# PENRITH CITY COUNCIL

## MAJOR ASSESSMENT REPORT

<b>Application number:</b>	DA18/0488.02
<b>Proposed development:</b>	Review of Determination - Demolition of Existing Structures & Construction of a 6 Storey Residential Flat Building containing 40 Apartments with Communal Roof Top Terrace & Basement Car Parking
<b>Property address:</b>	26 Hope Street, PENRITH NSW 2750 28 Hope Street, PENRITH NSW 2750 30 Hope Street, PENRITH NSW 2750
<b>Property description:</b>	Lot 34 DP 31239 Lot 35 DP 31239 Lot 36 DP 31239
<b>Date received:</b>	22 August 2019
<b>Assessing officer</b>	Paul Anzellotti
<b>Zoning:</b>	Zone R4 High Density Residential - LEP 2010
<b>Class of building:</b>	Class 2 , Class 7a
<b>Recommendations:</b>	Refuse

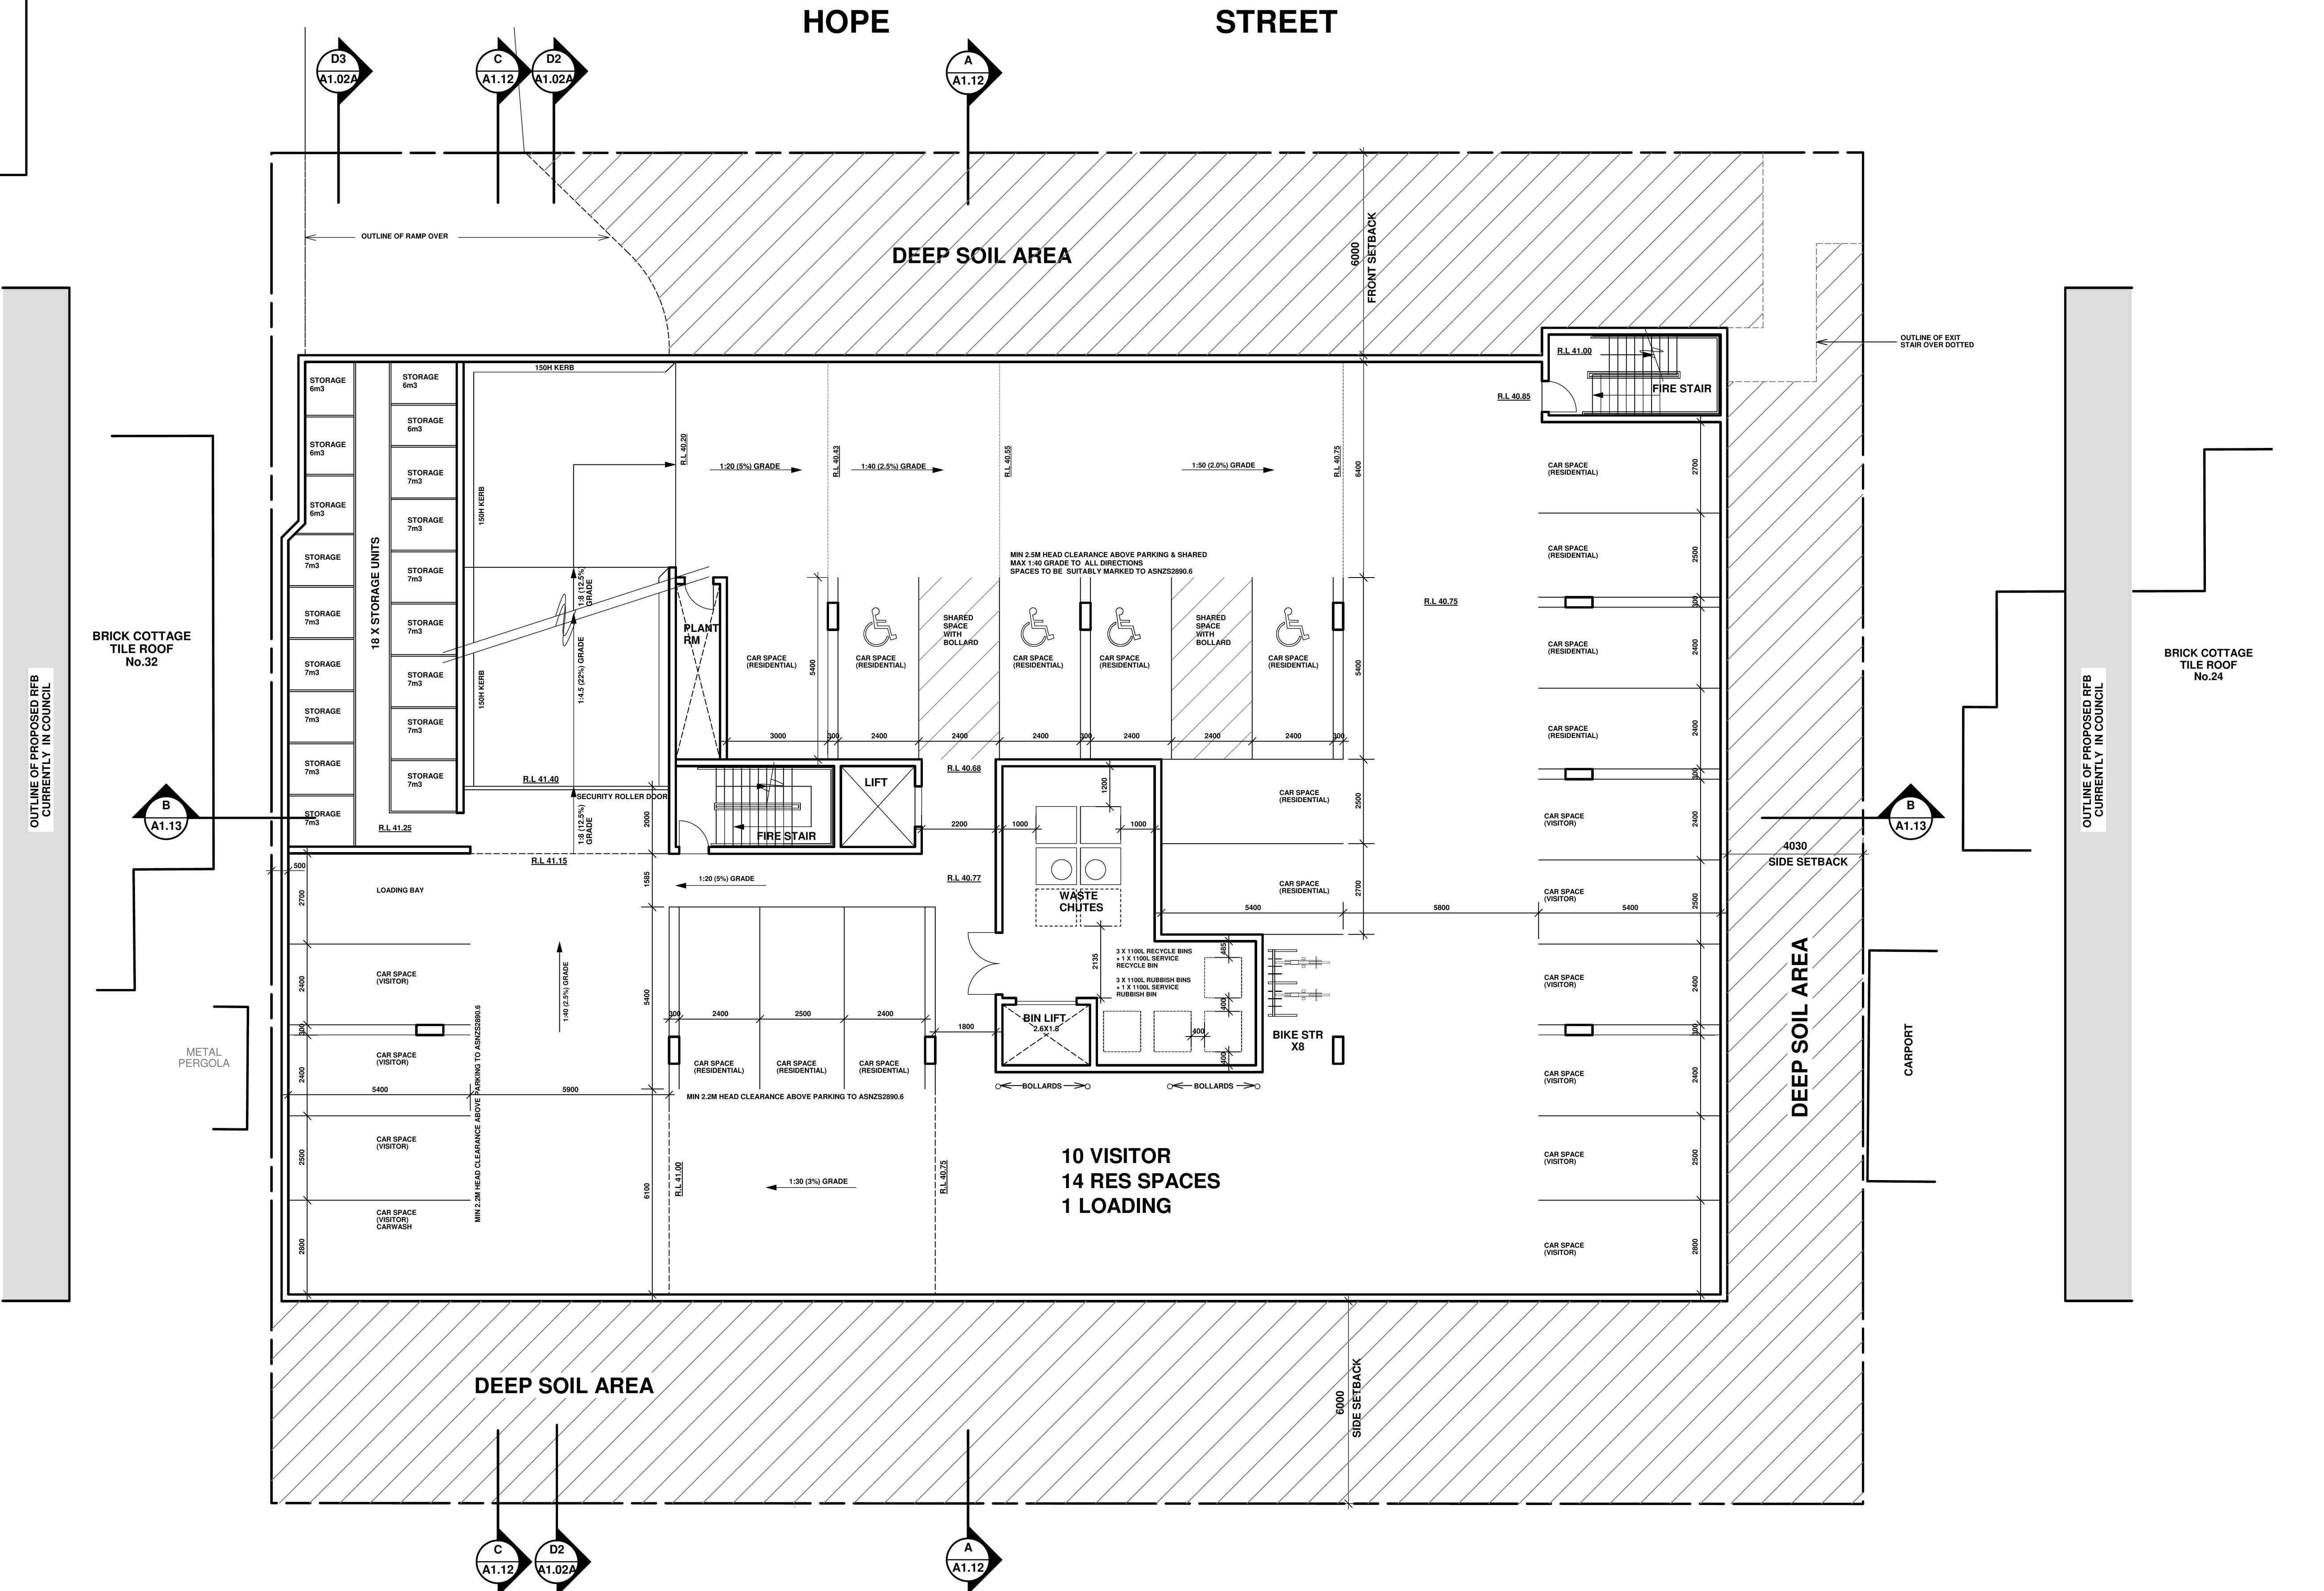
The landscaped/deep soil area at the rear of the building is able to be accessed by a set of stairs to the west of the waste bay, the design provided as per the original application determined. This also allows persons access to the perimeter of the building and to be able to walk along the side southern and eastern elevations. Due to the existing ground levels and relationship to finished floor levels for the ground and level 1 of the building (especially units 8, 9 and 10 which maintain balconies at a height of 1.8m to the balcony of unit 8, 1.4m to the balcony of unit 9, and between 1.3m and 1.8m to the balcony of unit 10) it is considered that there is a higher risk to safety for future occupants of these first floor units in particular, as they are not of a height to make them less inaccessible.

In addition, it is also considered that the revised layout will provide for the potential for persons to access the patio area of unit 3 with no distinguishable barrier provided between these respective areas to restrict the movement of persons.
